EDGERTON PLANNING COMMISSION AGENDA June 10, 2014 7:00 PM

STAFF REPORT

Re: Application S-05-15-14 for Final Site Plan for Edgerton Logistics Park Lot 1 on the north

Requested Action: Final Site Plan for Edgerton Logistics Park Lot 1

SHEET NO. C-2

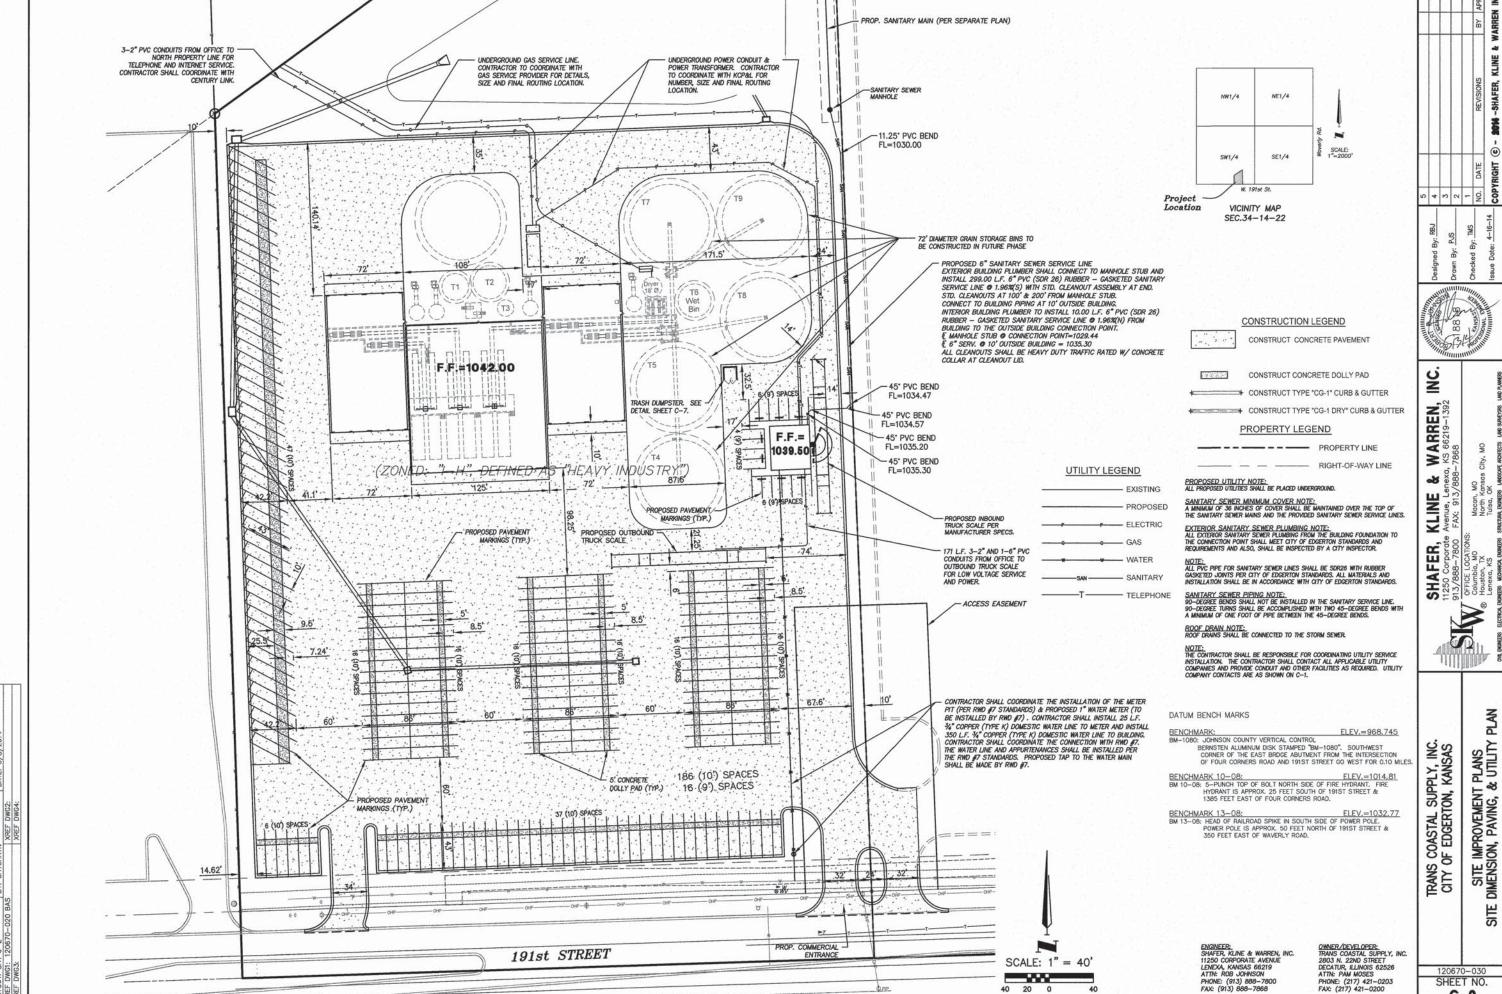
- v) Exterior lighting specifications. *Details, locations and photometric plan have not been provided.*
 - vi) Site entrance and connections to streets. *Proposed shared access is wide and would likely cause confusion regarding which side to enter/exit. Further review by a traffic engineer regarding exact placement and size of all entrances/exits should be submitted and approved by City Engineer prior to construction.*

- 5. All parking shall be on a surface prepared from concrete or asphalt. *Parking area material has been specified as concrete pavement but concrete dolly pads have been shown. Confirm parking lot material.*
- 6. All commercial buildings shall provide a designated off-street space for the loading and unloading of goods and merchandise. *Final Site Plan complies*.

- d. Submittal of revised shared access point to be reviewed and approved by City Engineer
 - e. Submittal of necessary storm water documentation for review and approval by the City

IRANS COASTAL SUPPLY, INC. CITY OF EDGERTON, KANSAS	SITE IMPROVEMENT PLANS STORM SEWER CALCS
TRANS CO	SITE IMPR STORM
12067 SHEE	0-030 T NO. -6

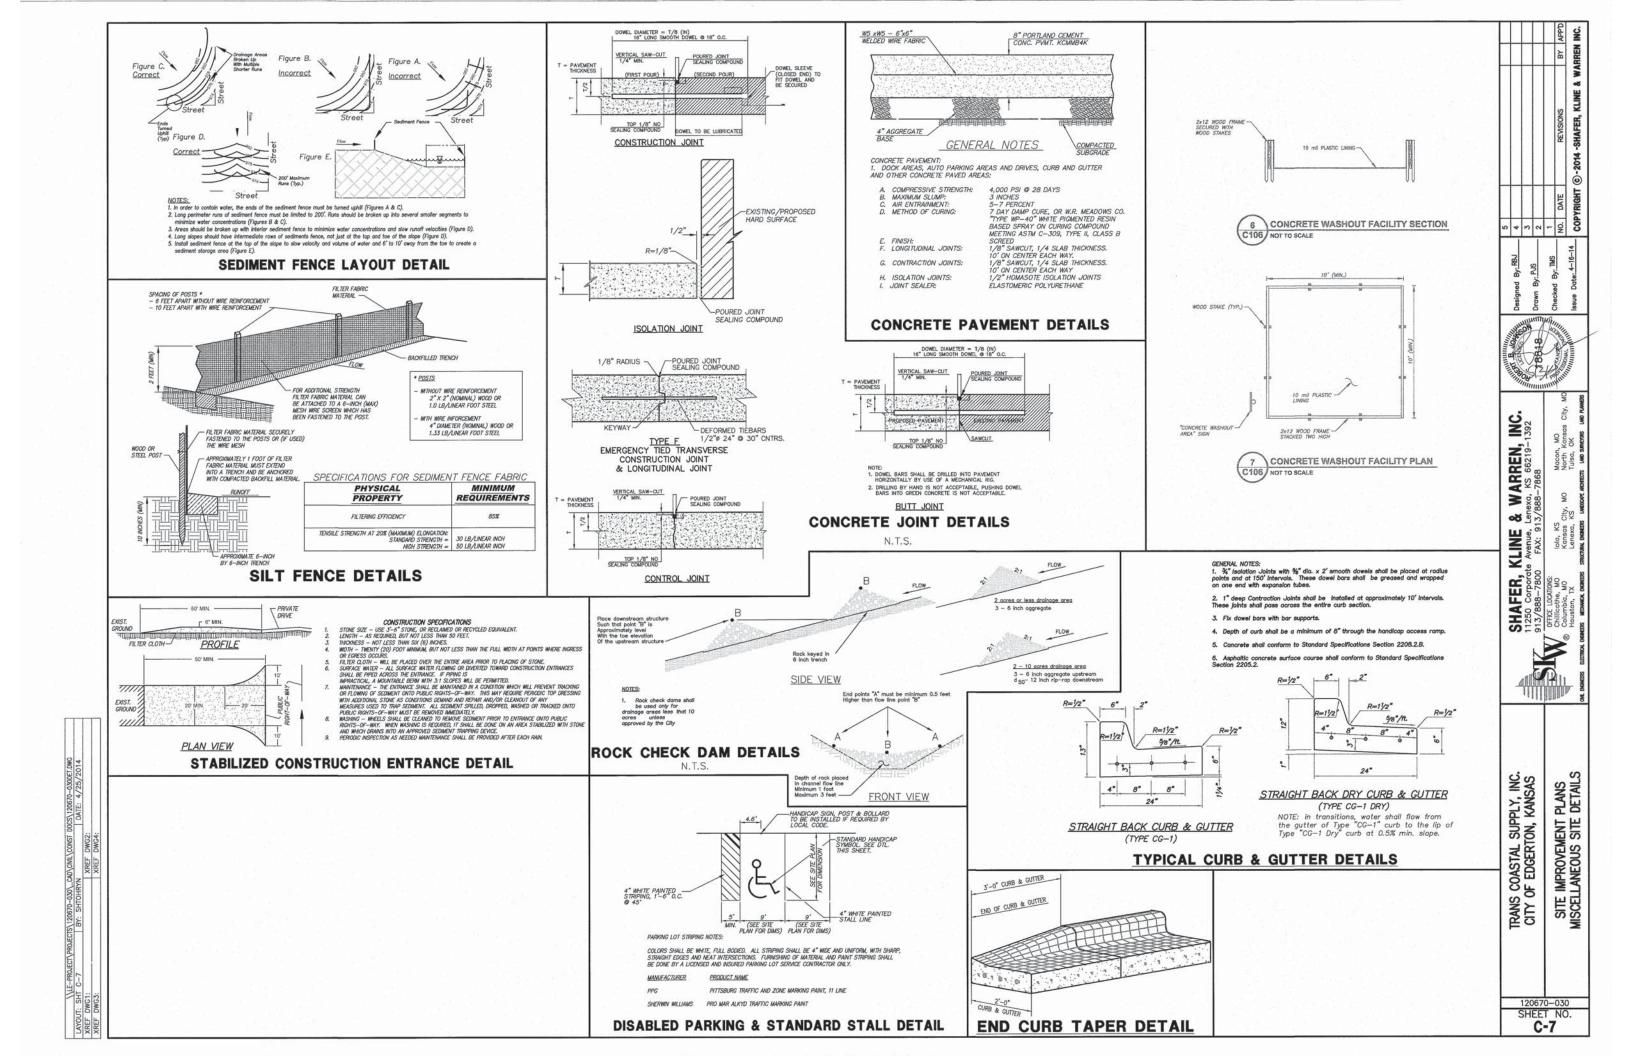
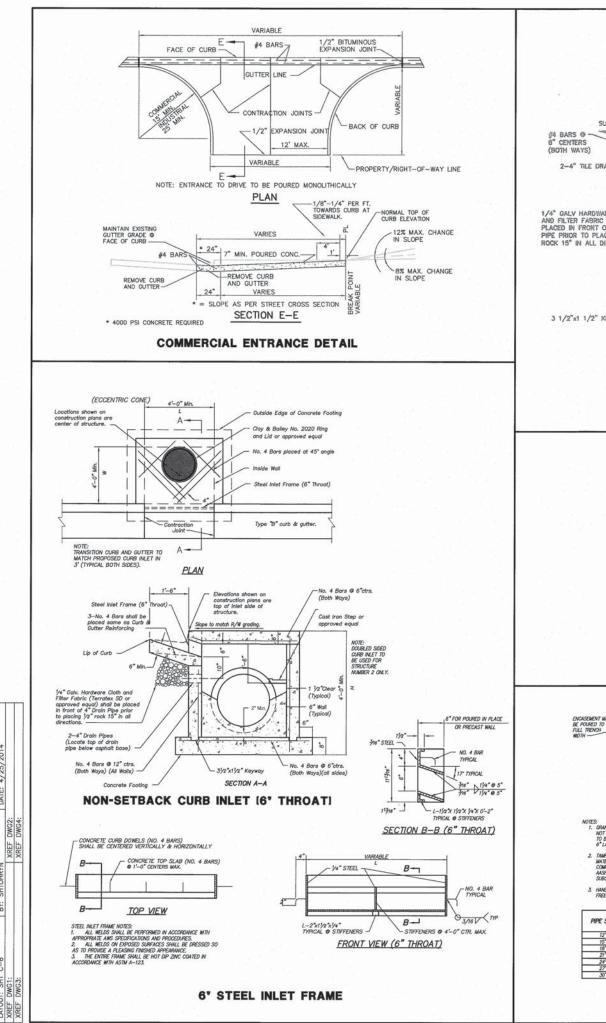
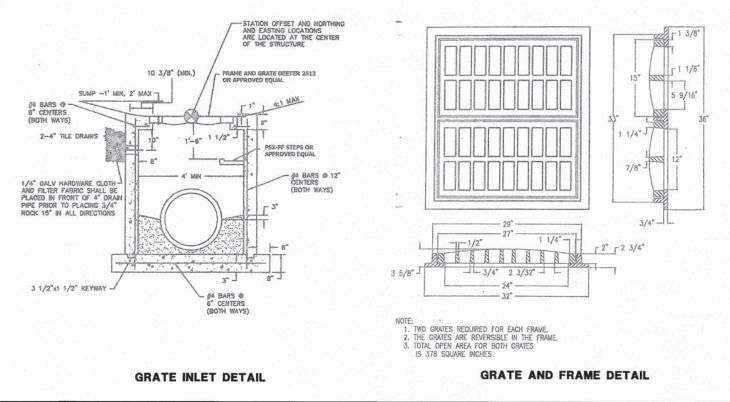
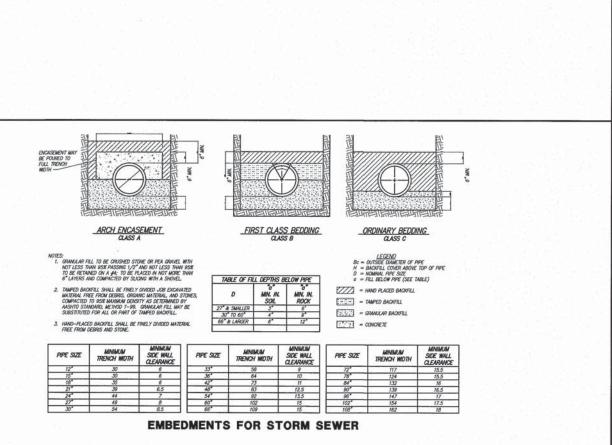
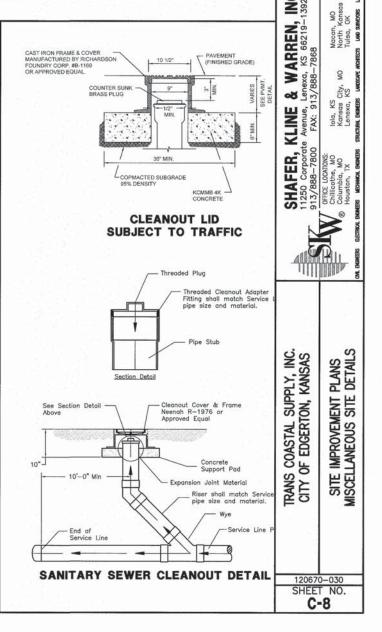
- The Orifice Assembly detail shown on Sheet C-6 is not clear. Indicate what is existing and what is proposed. Note size of existing pipe.
- Include contact information for Edgerton Wastewater in the Utility Contact Information on Sheet C-1.
- Fire hydrants have not been shown clearly on the site plan. Fire hydrants may be necessary to meet Fire Code requirements.
